**Responses from McKinney York Architects to CoA Cara Bertron (CB) in response to an email sent to contractor James Nolan '3803 Avenue H – historic review questions' dated 06.15.2020:**

Prepared by Charles Horn at MYA on 06.16.2020

KEARNS RYALL RESIDENCE

3803 AVE H  
AUSTIN, TEXAS 78752

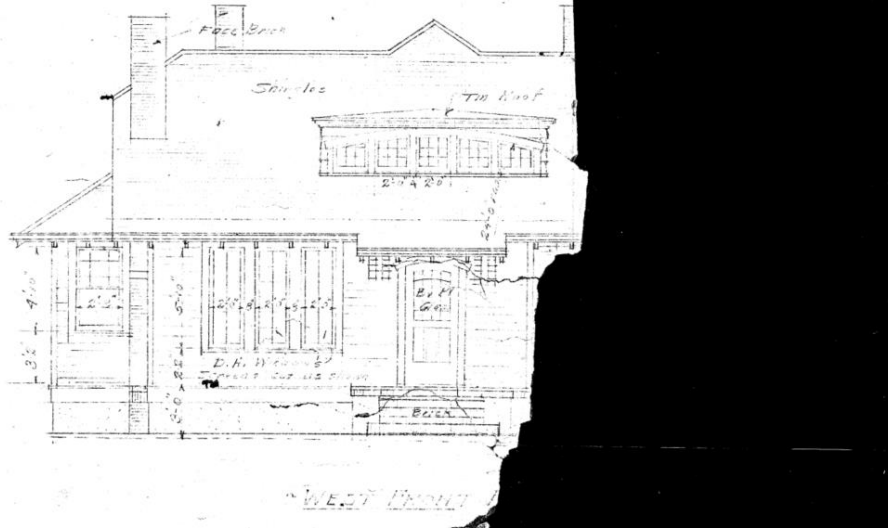
A) *The new dormer should replicate the historic dormer in roof shape and slope; window size and configuration; and roof, wall, and window materials. This is especially important since the house is a historic landmark.*

- *The roof shape isn't clear from the photos—is there evidence in the roof construction where it tied in?*
- *The window configuration and lite patterns should match the photograph exactly.*
- *The roof covering should be shingles to match existing.*

**The new dormer** on the west facing roof of the house was designed directly from the historic architectural drawings prepared by Roy L Thomas for Otto Bengtson on June 19<sup>th</sup>, 1925. This dormer was removed during a renovation done prior to the current owners, and no known photographs of it exist other than this historic image provided by the current owners:

The only change from the original design our current proposal makes is to raise the roof of the dormer to lift the interior ceiling of the dormer. The attic in its original configuration was not intended to be occupied and the original dormer ceiling height would not have been occupiable by a resident. Aside from raising the ceiling, all other dimensions are the same as the 1925 drawings. The sill of the dormer is set in the same location as the original design drawings show, and the width of the dormer is identical. The curvature of the header is also reproduced, and the trim and cornice conditions are recreated. Additionally, **the window configuration** is drawn directly from the original, the sashes used are the original sashes, discovered in the garage on the property by the current owners of the house. Our design documents submitted for permit show a double hung sash window. On April 23<sup>rd</sup> of this year the drawings were revised to be casement

windows. This change was made both for constructability, and to more closely match the original dormer, as the windows were all in one plane and likely fixed. Two rows of glass lites identically proportioned to the original have been added to accommodate the change in ceiling height. Here is a photo of one of the original windows being extended:

Please see the following drawings for a graphic comparison of the original documents to the present proposal. All other cladding materials on the dormer are to be replicated per the original design drawings.

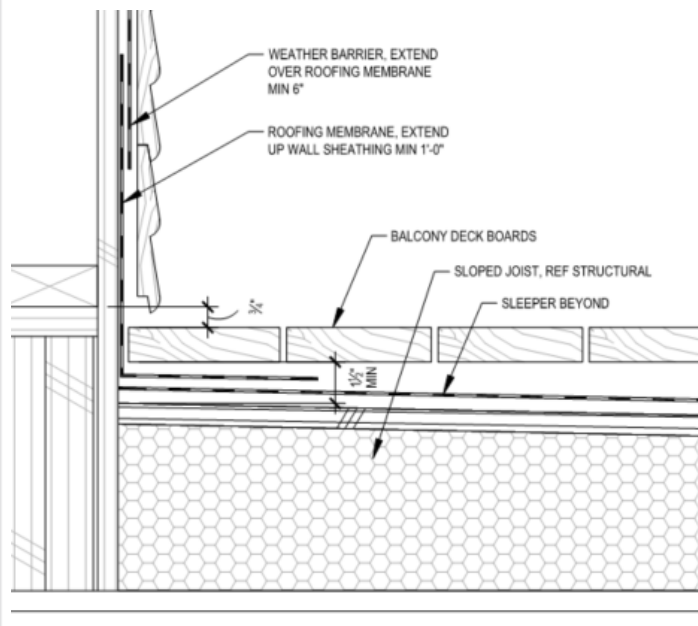
1) Can you send photographs of the rear and side elevations, please? I'd especially like to know what the existing porch and rear wall look like, and if there are windows in the side gable ends.

**MYA RESPONSE:** Photos of all elevations of the house will be returned to you along with this document.

### BALCONY AT INTERIOR WALL 03

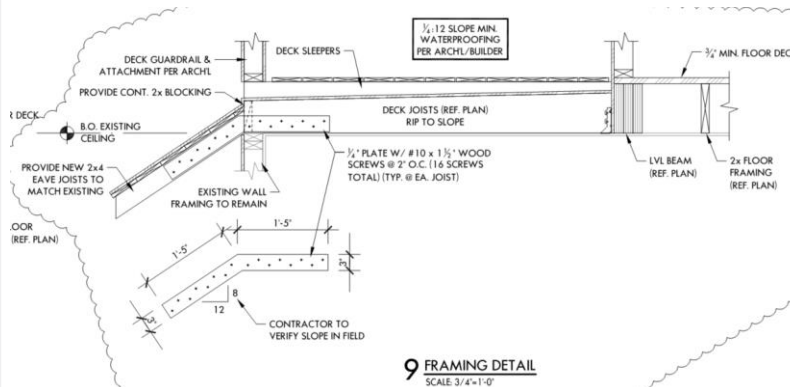
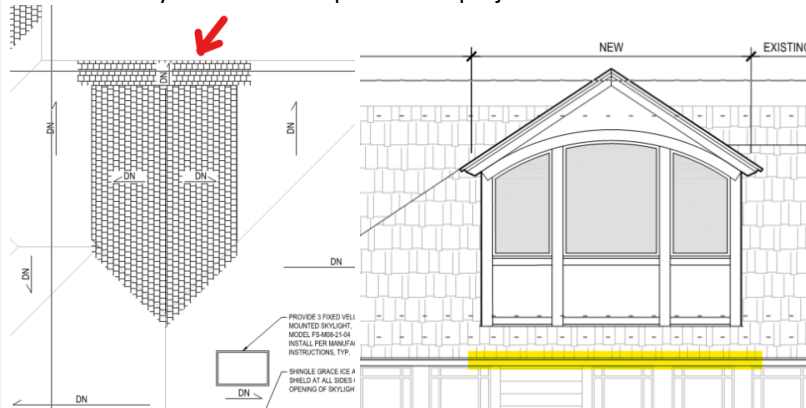
3) What is the proposed wall material for the second-floor addition wall, to the west of the balcony?

**MYA RESPONSE:** The second-floor balcony dormer that faces east has walls that are visible in the south and north elevations. They are to be clad with wider wood siding material to match the historic materials on the west dormer. On the interior of the balcony, the wall facing east is to be clad with wood teardrop siding to match other areas of the house. Please reference the following detail:

SOUTH ELEVATION 02  
SCALE: 1/4" = 1'-0" @ 22x34 | 1/8" = 1'-0" @ 11x17

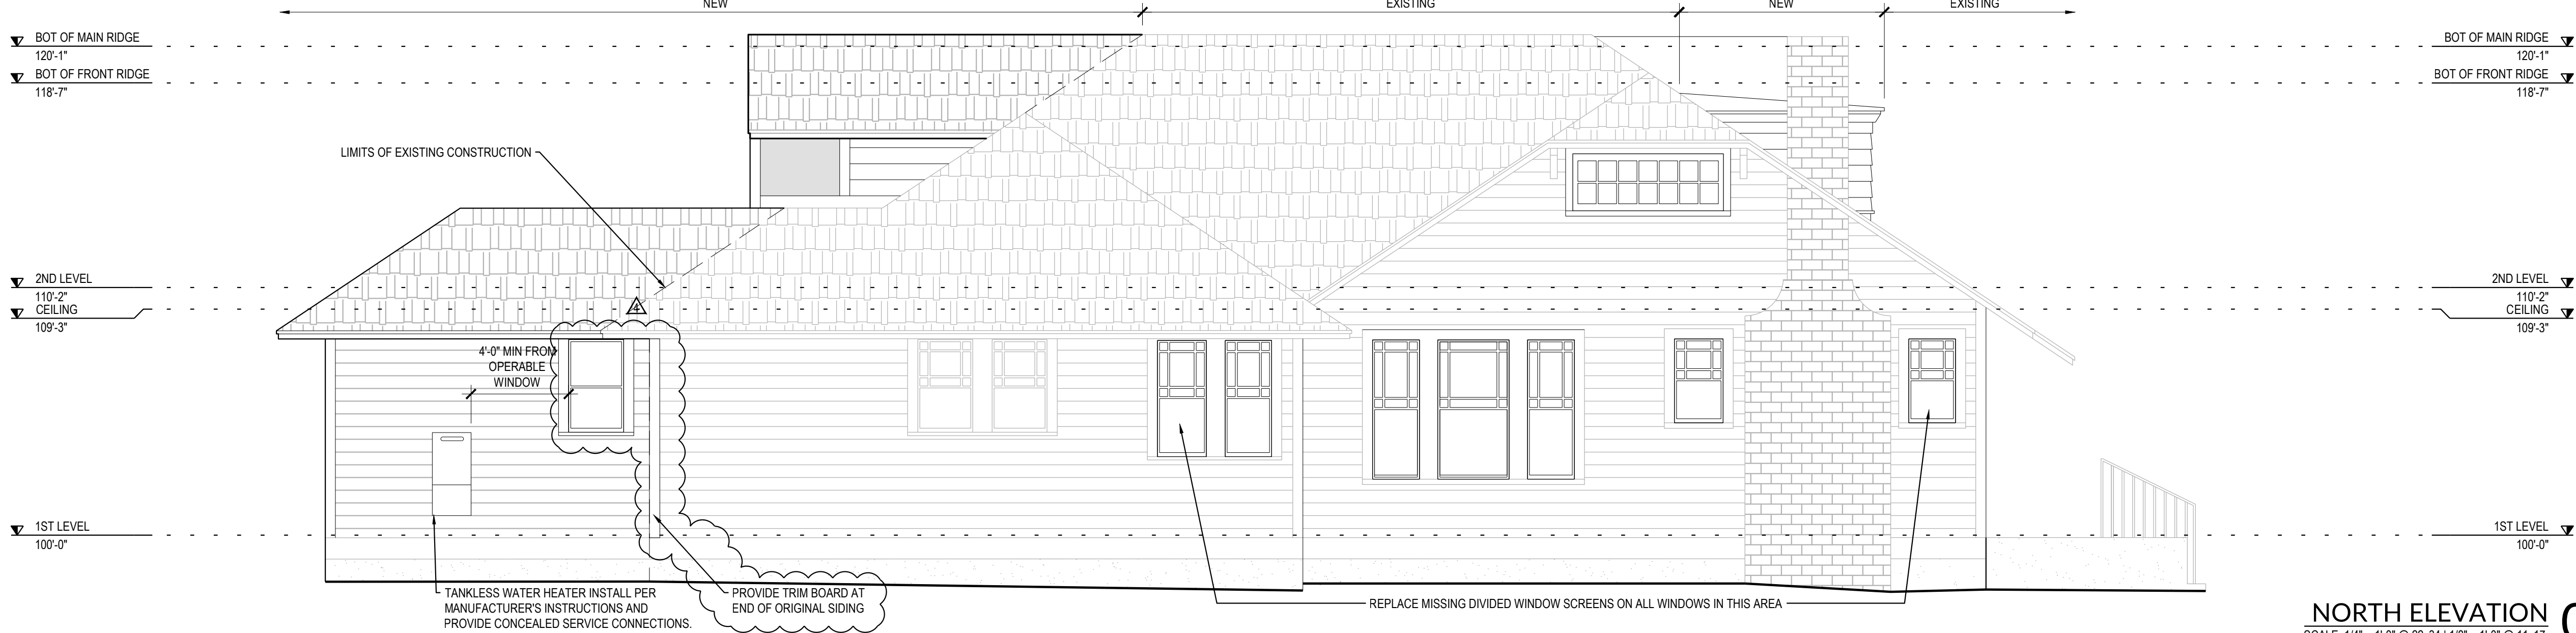
8) *The new skylights on the south roof slope appear on the roof plan but not the elevation – which is correct? If they are proposed, will they be visible from the street?*

**MYA RESPONSE:** The skylights are included in our proposal. They have been added to the elevation for your reference and attached to this document. The skylights would be entirely invisible from the straight-on view of the west facing façade from the street.
